## TECHNICAL MEMORANDUM

**Project No.** CA-GLD-1791470A-VCNA

### **SUPPLEMENTAL ASSESSMENT OF POTENTIAL IMPACTS TO BASEFLOW IN MILL CREEK AND TRIBUTARY 3 – PROPOSED CBM ABERFOYLE SOUTH LAKE PIT**

**Figure 1: Surface Water Stations on Mill Creek and Tributary 3 (SW1 to SW4), and modelled surface water stations (SW-M1 to SW-M3) at the confluence of Tributary 3 and Mill Creek.**

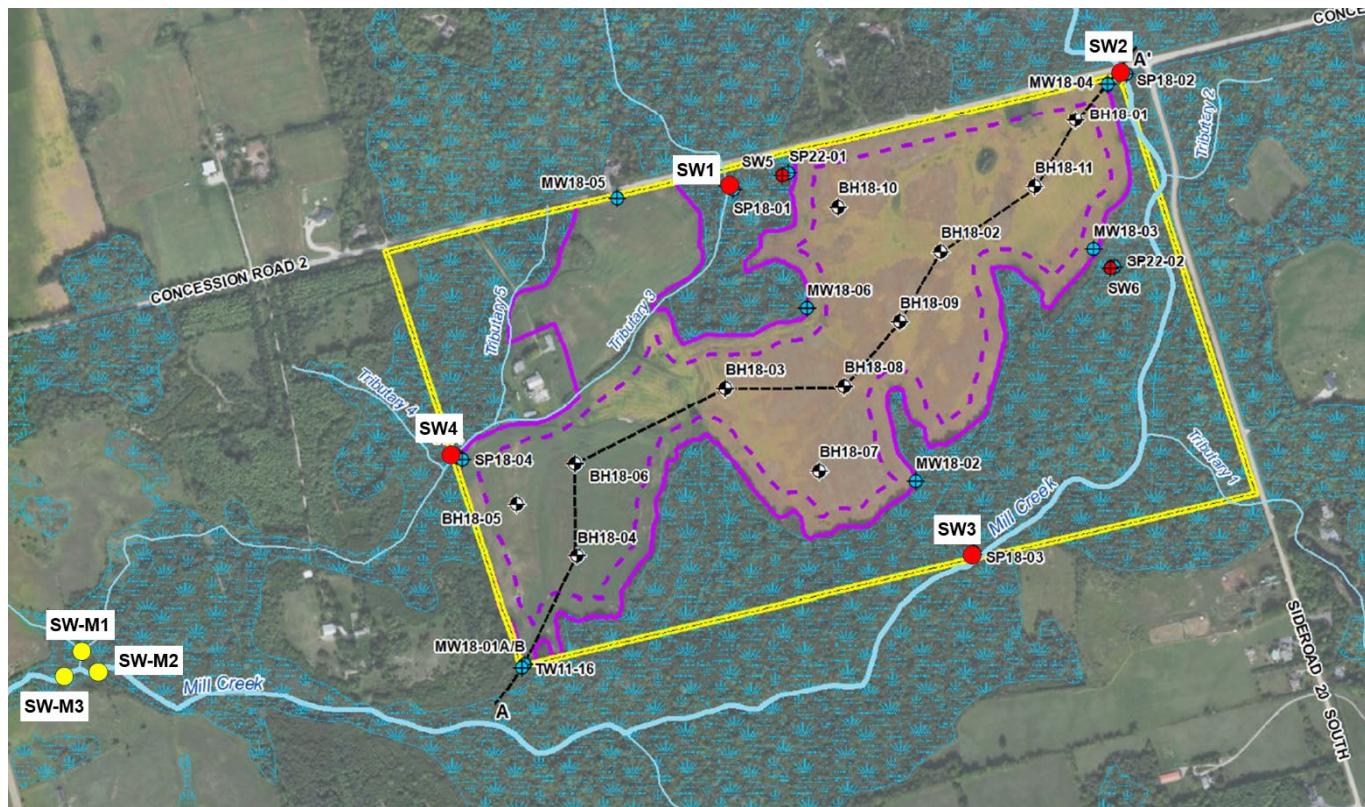
A number of comments from stakeholders expressed concern regarding the potential for impacts to baseflow in Mill Creek and Tributary 3 as a result of the proposed aggregate pit development post-rehabilitation. This technical memorandum provides a supplemental assessment of these potential impacts, in order to provide clarity and context to the predicted changes to baseflow.

To clarify and further illustrate the redistribution of baseflow as originally described in the Water Report, modelled surface water stations (SW-M1, SW-M2, and SW-M3) were introduced at the confluence of Tributary 3 and Mill Creek, downstream of the area of redistributed baseflow, at the locations shown on Figure 1. These simulated stations were added without any alteration or recalibration to the model. The resulting baseflow predictions for the previous and new modelled surface water stations under current conditions and post-rehabilitation are shown in Table 1 and discussed below.

- At SW-M1, downstream of SW4 on Tributary 3, baseflow increases by 90 m<sup>3</sup>/day, an increase of 7% in post-rehabilitated conditions compared to current conditions.
- At SW-M2, downstream of SW3 on Mill Creek, but above the confluence of Tributary 3 and Mill Creek, baseflow decreases by 75 m<sup>3</sup>/day, a 1% decrease in post-rehabilitated conditions compared to current conditions.

- At SW-M3, downstream of the confluence of Tributary 3 and Mill Creek, there is essentially no net change in baseflow (0.1% increase between existing and rehabilitated conditions).
